In the matter of the Proposed Waimakariri District Plan

**Council Officer's Preliminary Response to written questions on Rezoning –
Oxford and Settlement Zone (Ohoka and Woodend Beach) on behalf of
Waimakariri District Council**

Date: 31 May 2024

Figure 14 – Suspected GNS Faults across the Southwest Area – Source: WAIMAP

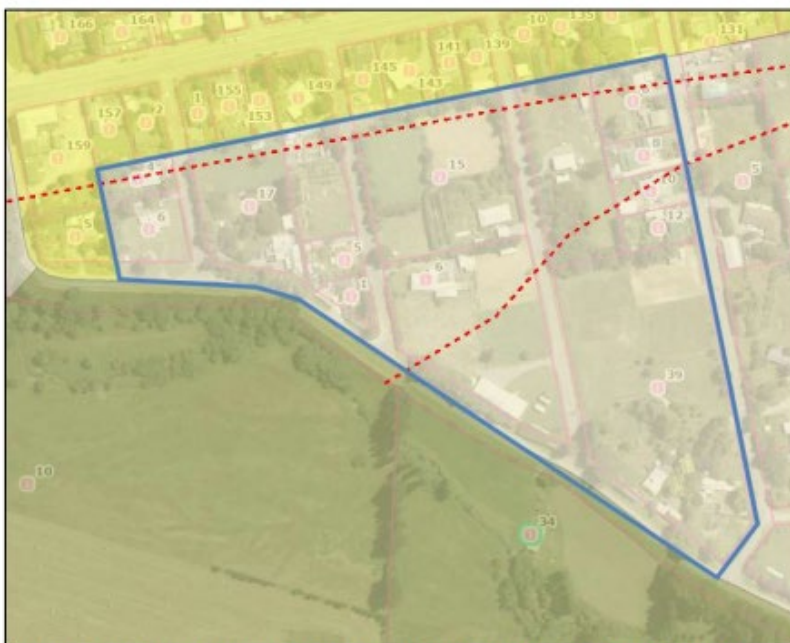
The Panel is finding it difficult to reconcile your position of not recommending rezoning this land to GRZ, given our understanding that large areas of Waimakariri that are proposed to be zoned GRZ or MRZ and allow for greater levels of development than in the ODP are subject to natural hazards.

The active faults and folds of the Waimakariri District have generally been mapped at a scale of 1:250,000, the Ashley Fault Zone is the exception⁵. This scale highlights those areas potentially affected by active faults or fold hazards and identifies locations for further investigations. The figure⁶ below shows the suspected Starvation Hill Fault across the submission area as the two red dashed lines. It should be noted that this is only the *suspected* location of the Starvation Hill Fault and the red dashed lines are an indicative location only. Mr Aramowicz has advised me that this is not an accurate representation of where historic ground rupture occurred. His opinion is that Council does not have sufficiently accurate information to determine where exactly new buildings should be avoided, and where new buildings could be established away from the likely rupture surface.

The submitters have not provided any technical information to assist Council in understand where the fault scarp is located. Given this, the advice from Mr Aramowicz is that he is unable to differentiate between areas where buildings should be limited to light timber framed structures on shallow timber piles (Importance level 1 and 2a), and the other areas where the effects of fault rupture are less likely to cause destruction and life safety issues.
